ENVIRONMENTAL REVIEW COMMITTEE REPORT

ERC MEETING DATE: October 26, 2015

Project Name: Kinkade Crossing Preliminary Plat

Project Number: LUA15-000695, ECF, MOD, PP

PP-03
3 of 6 SHEETS

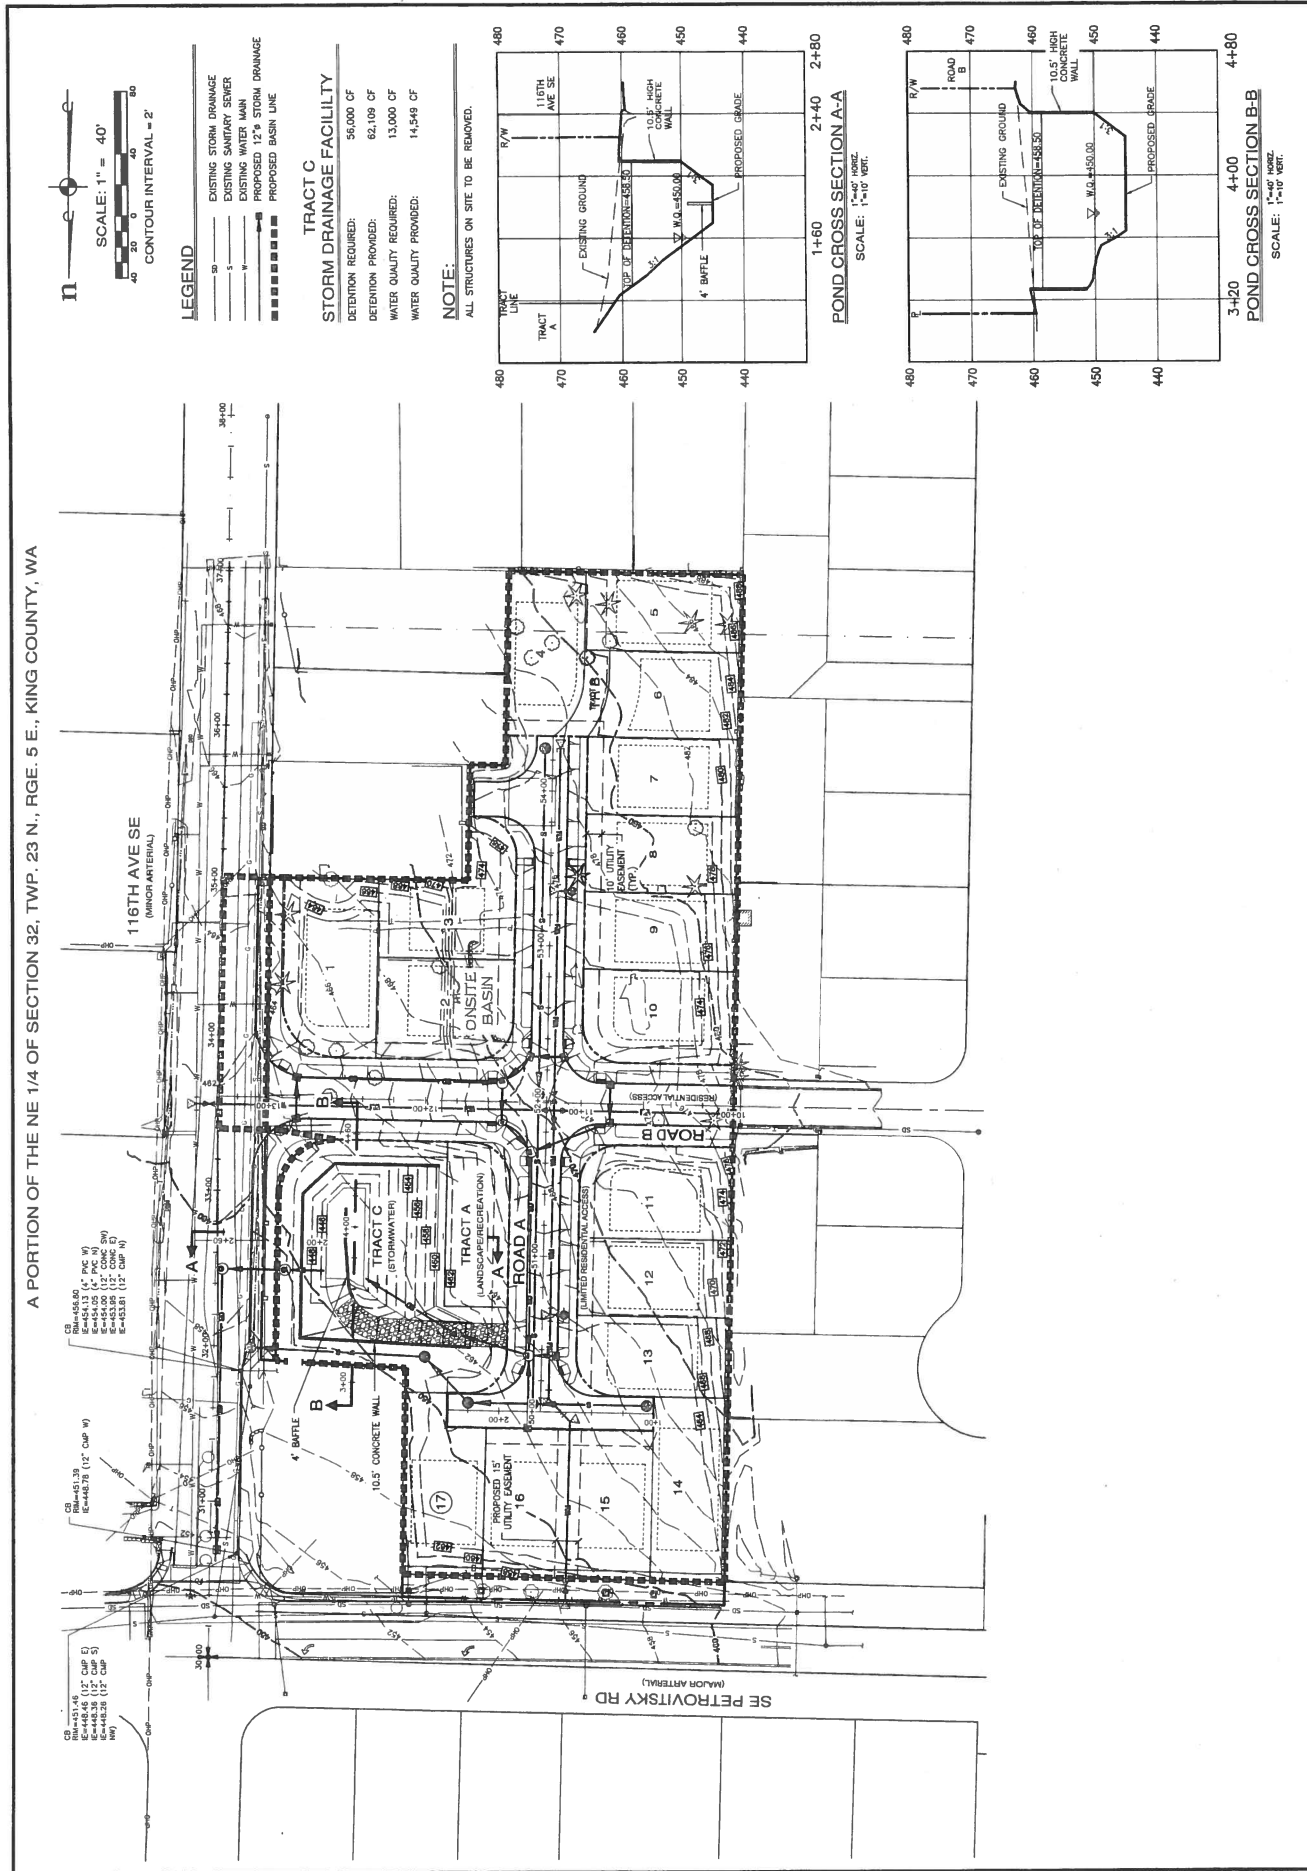
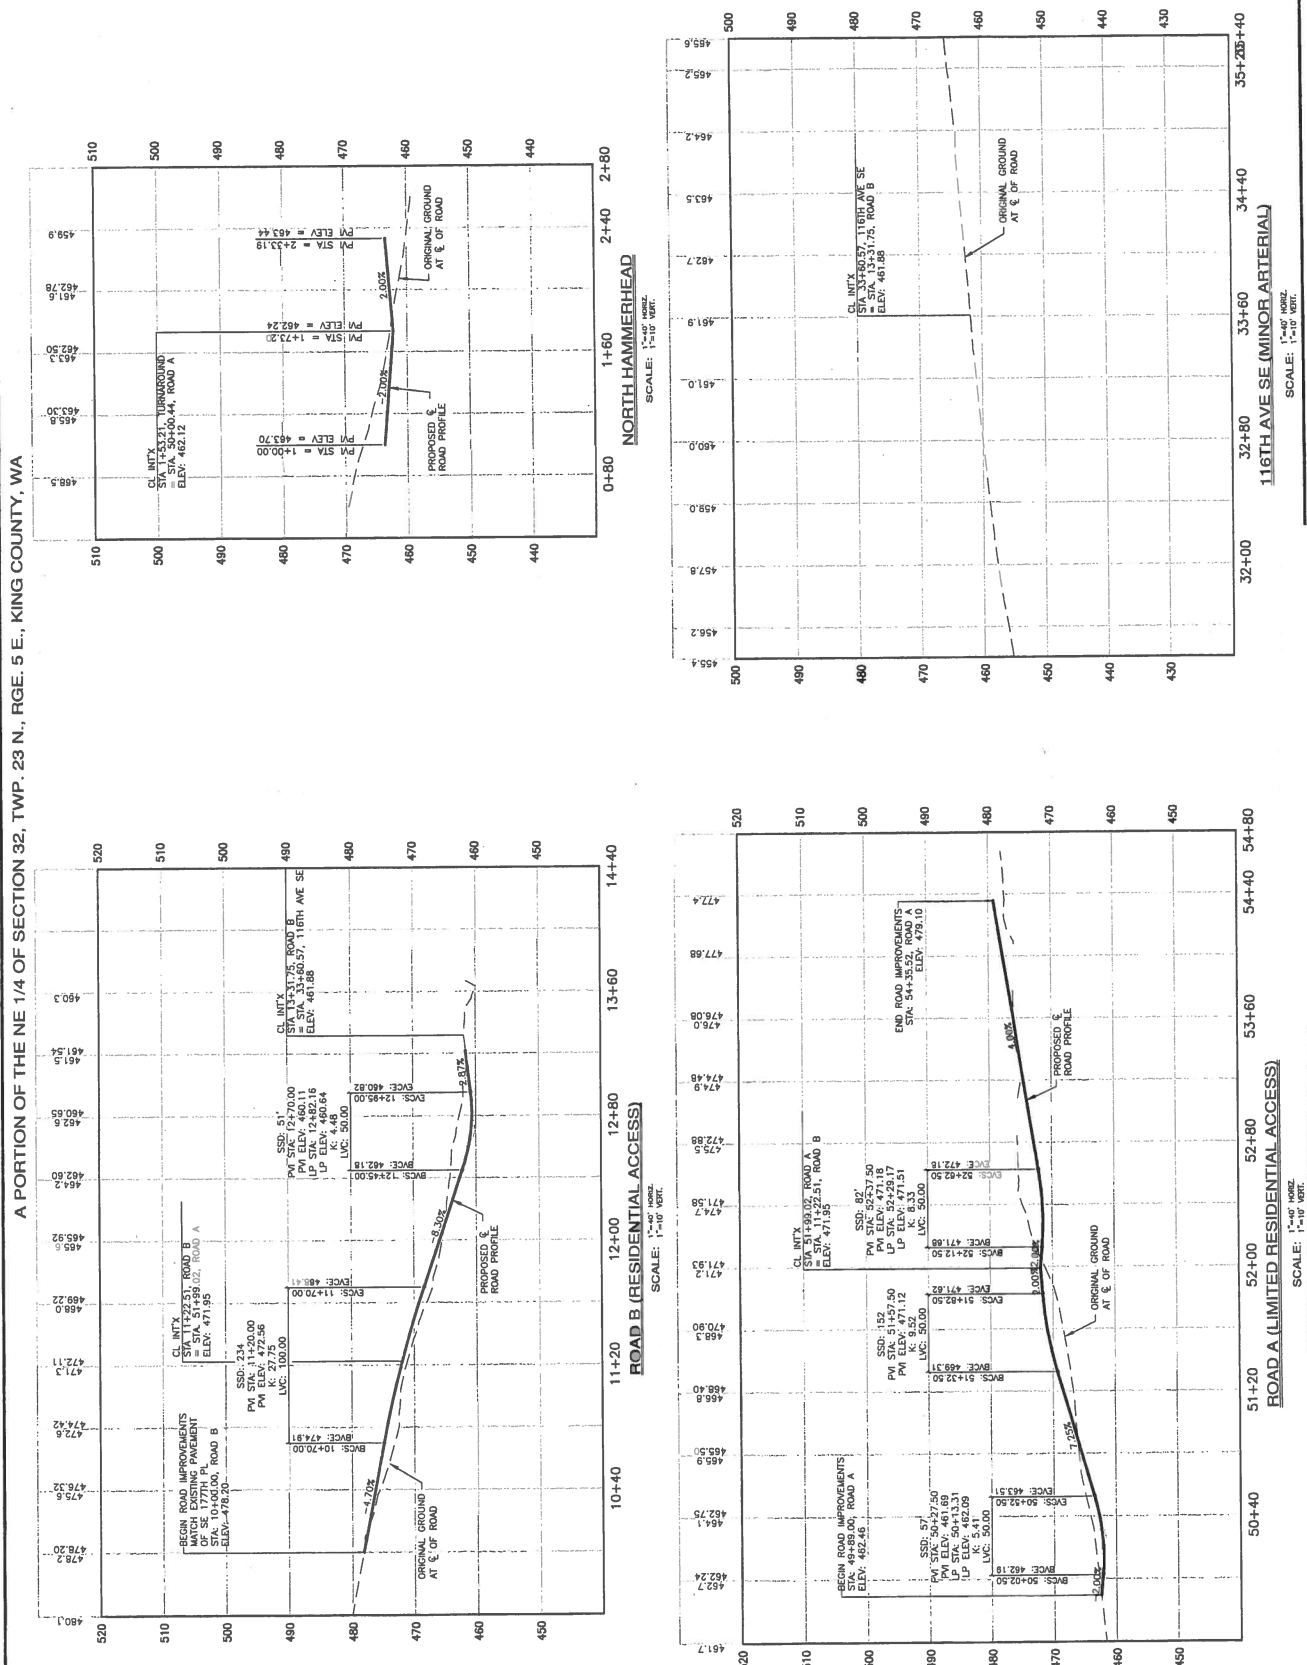
8. The allowed maximum slope back of sidewalk is 4H:1V. The current plans showed a slope of 2H:1V, which should be corrected in the plans given with the utility construction permit.
